(Grain Belt Express Comments on Ameren
Missouri's 2023 Integrated Resource Plan)

BEFORE THE MISSOURI PUBLIC SERVICE COMMISSION

In the Matter of Union Electric Company d/b/a)
Ameren Missouri's 2023 Utility Resource Filing) Case No. EO-2024-0020
Pursuant to 20 CSR 4240 – Chapter 22)

GRAIN BELT EXPRESS COMMENTS
TO AMEREN MISSOURI'S IRP

⁴⁵ 2023 IRP, figs 6.4 & 6.7.

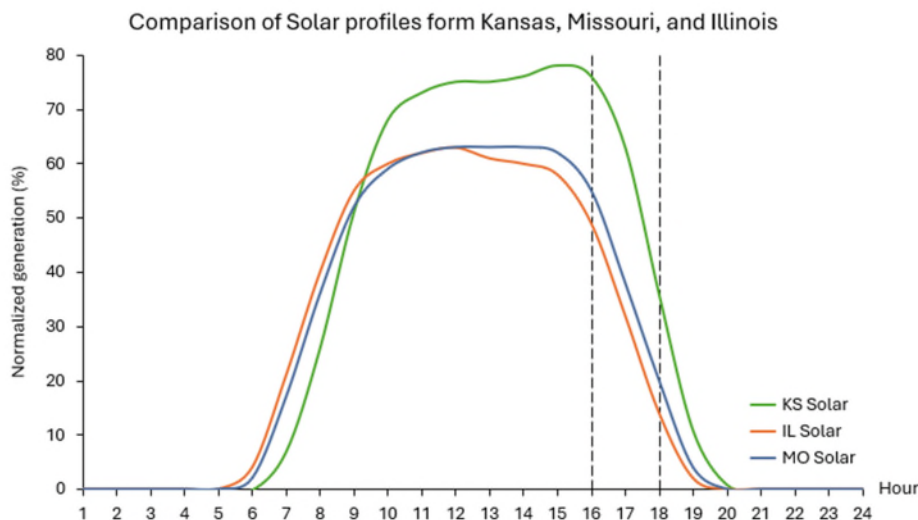
Ameren claims that their plan is to consider geographic diversity later, during "implementation."⁴⁷ Again, if Ameren has not considered the Project and associated generation
